Proposal To vary conditions of planning permission ref. 20/00418/FUL - Erection of 2 no. semi-detached and 4 no. detached dwellings following demolition of existing vacant care home and garages, together with provision of associated hard surfaces, footways, and drainage infrastructure - to allow for minor material amendments (larger houses) to the development

Location Bowlacre Home Stockport Road Hyde Tameside SK14 5E

Application No. 21/01113/FUL

Mabbett response

Appendix B – Drainage Sketch

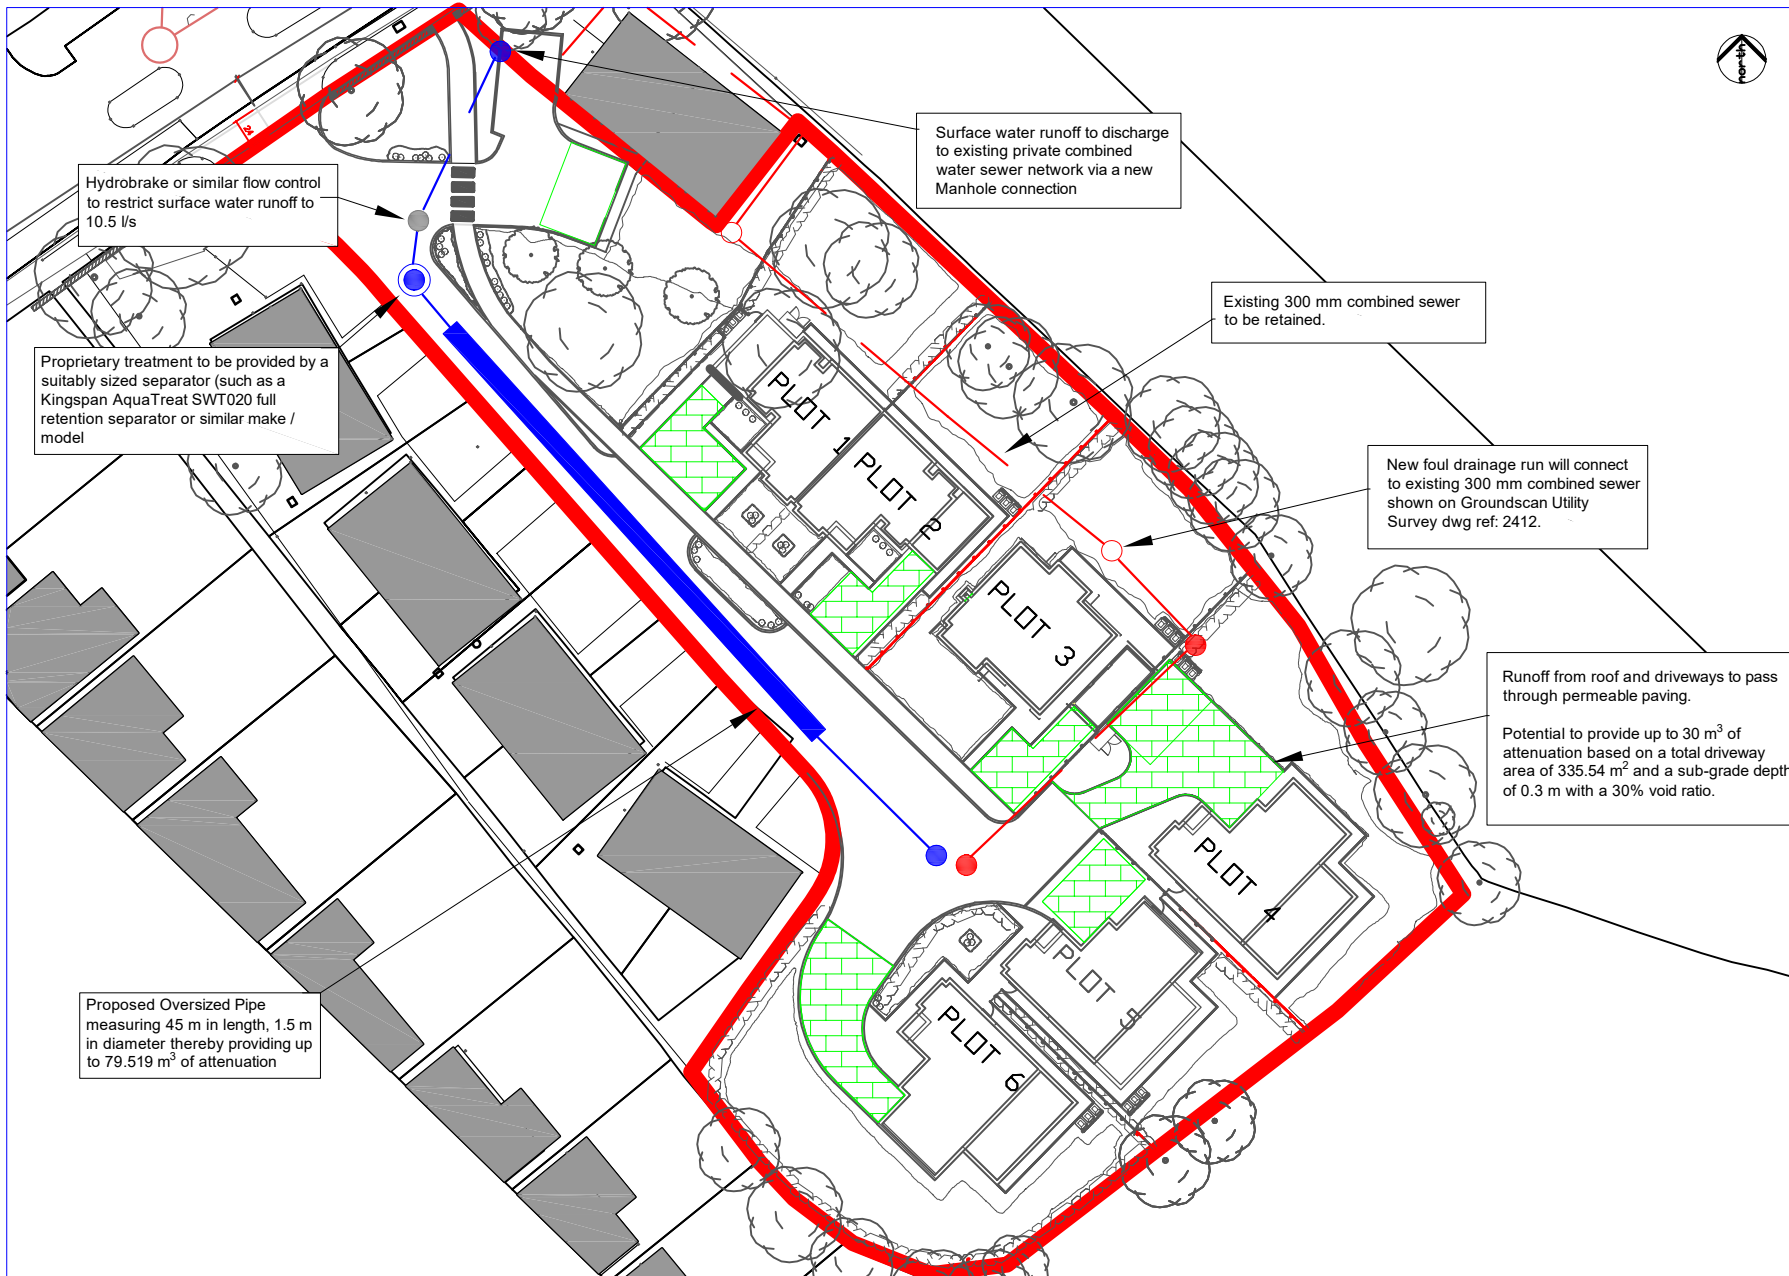
“Further to our review of the submitted Drainage Strategy (ref 22-1179.01, issued July 2022) United Utilities recommends that condition 4 is not discharged. This is because we have doubts about the existing runoff rate calculated and do not agree with the proposed rate of 10.5 l/s. Regardless, all sites should aspire to meet greenfield runoff rates and we therefore request surface water is restricted to 5 l/s.”

Nevertheless, as the United Utilities have stated '*all sites should aspire to meet greenfield runoff rates and we therefore request surface water is restricted to 5 l/s*'. This rate has been used in our revised attenuation calculations.

When attenuating for the previous proposed brownfield discharge rate of 10.5 l/s, for the 1 in 100 year +40% CC event, 99.8m³ of attenuation was required on-site, calculated using MicroDrainage Source Control Calculations for a proposed pipe. Whereas when attenuating for the proposed rate of 5l/s, for the 1 in 100 year +40% CC event, an amount of 110 m³ of attenuation is required, calculated using Causeway Flow (Appendix A). To accommodate for the additional storage, it is proposed to lengthen the oversized pipe by 5 metres. A proposed Drainage Sketch is included as Appendix B to this document.

- **Proposed Oversized Pipe**
45m in length, 1.5m in diameter providing 79.519m³ of attenuation
- ▨ **Proposed Porous Paving Area**
335.54m² with a subgrade depth of 0.3m and a void ratio of 30% providing approx. 30m³ of attenuation
- Indicative Route of Proposed Surface Water Sewer
- Approximate Route of Proposed Foul Sewer
- Approximate Route of Existing Private Combined Sewer
- Approximate Route of Existing Public Combined Sewer
- Existing Combined Sewer Manhole
- Existing Private Combined Sewer Manhole
- Proposed Foul Water Manhole
- Proposed Surface Water Manhole
- Proposed Flow Control Device (Hydrobrake or similar)
- Proposed Proprietary Separator such as Kingspan AquaTreat SWT020 full retention separator or similar make/model
